**Report Type:** DA Access Report  
**Reference Number:** 19257  
**Client:** Growth Built  
**Site Address:** 14-18 Phillip Street, St Marys NSW

# ACCESS REPORT

This Access Compliance Report is to accompany a Development Application for the development proposed at 14-18 Phillip Street, St Marys NSW.

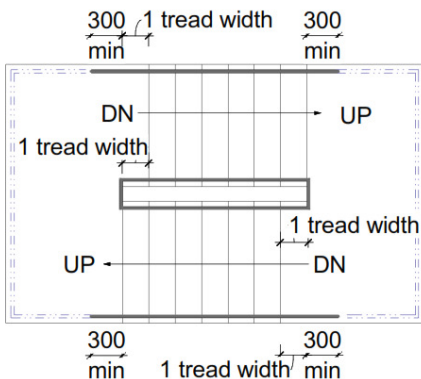
<b>Compliance Comments</b>	<p>Capable of compliance – refer to the mark ups.</p> <p>In common use areas, all single hinged doors and in case of multiple leaf doorways, at least 1 operable leaf is required to provide a clear opening of 850mm with the door circulations spaces as per AS1428.1-2009.</p>  <p>Note that the circulation spaces (other than doorway threshold ramp) to have a maximum floor grade of 1:40. Where there is a level difference at the door threshold, the maximum level difference can be 35mm if provided with a 1:8 doorway threshold ramp.</p> <p>This is achievable and the door selections are to be verified at CC stage of works.</p>

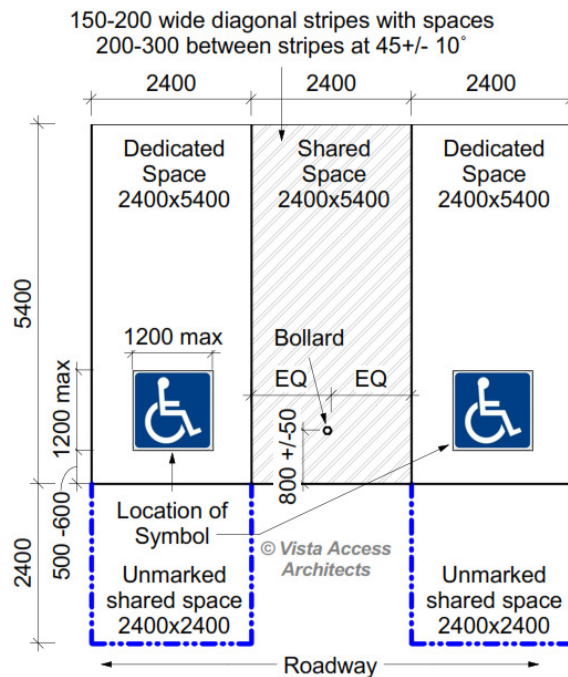
<b>Compliance Comments</b>	<p>Capable of compliance.  Details to be verified at the CC stage of works.  Refer to diagrams below for requirements, especially in regards to head height requirements.</p> <p><b>Note:</b> The pavement marking shall have the appropriate slip resistance for the location. This requirement is to be added to the project specifications to ensure compliance.</p>  <p>Head heights for both dedicated accessible parking space and the shared zone to be as shown above. No beams, pipes, sprinklers or any other encroachments are permissible for the entire 5.4M width of the dedicated and shared zone as per Section shown above.</p>

The Accessible parking, shared zones, linemarking and bollards to be as shown above.  
Access symbol is not to be provided when spaces are allocated to Adaptable units.
